DEPARTMENT OF ENVIRONMENTAL SERVICES
Division of Transportation and Development
Development Services Bureau

Below are the responses to the questions received at the May 13, 2013 Meeting held at the Williamsburg Auditorium for the Williamsburg Boulevard and Kensington Street Intersection Project (N514). We made an effort to group the questions by topic since there was overlap with many of the submissions. We have made every effort to respond to all the questions submitted that evening, which were also answered by staff who attended the meeting. Thank you.

The figure below shows all the six period plotted on the MUTCD chart for Warrant 3.

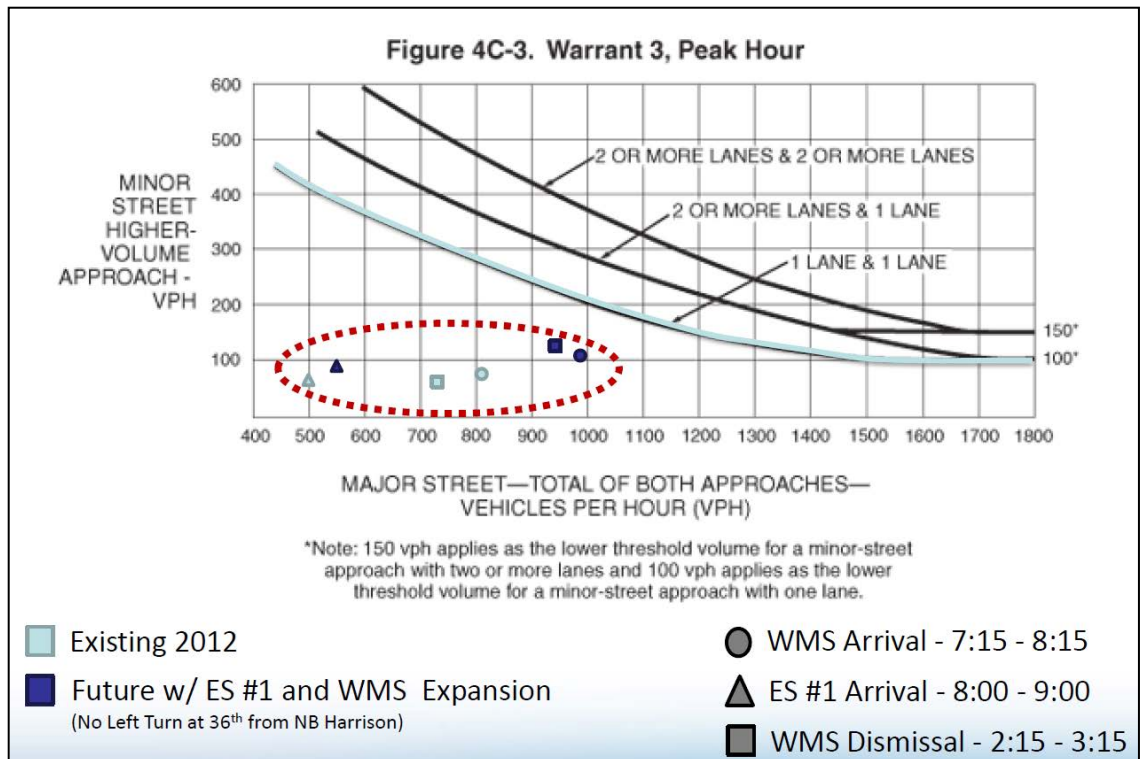
21	Q2	Could you discuss how the county determined that the intersection does not meet warrants for installation of a traffic signal?
----	----	--

To analyze Warrant 3 for Peak Hour Volumes staff looked at 6 possible peak hours, using count data for 3 existing hours along with traffic volumes for 3 projected future hours. In both cases, existing and future, the same three hour periods were studied;

The figure demonstrates that none of the six periods reviewed would meet the minimum requirements for Warrant 3, ruling it out.
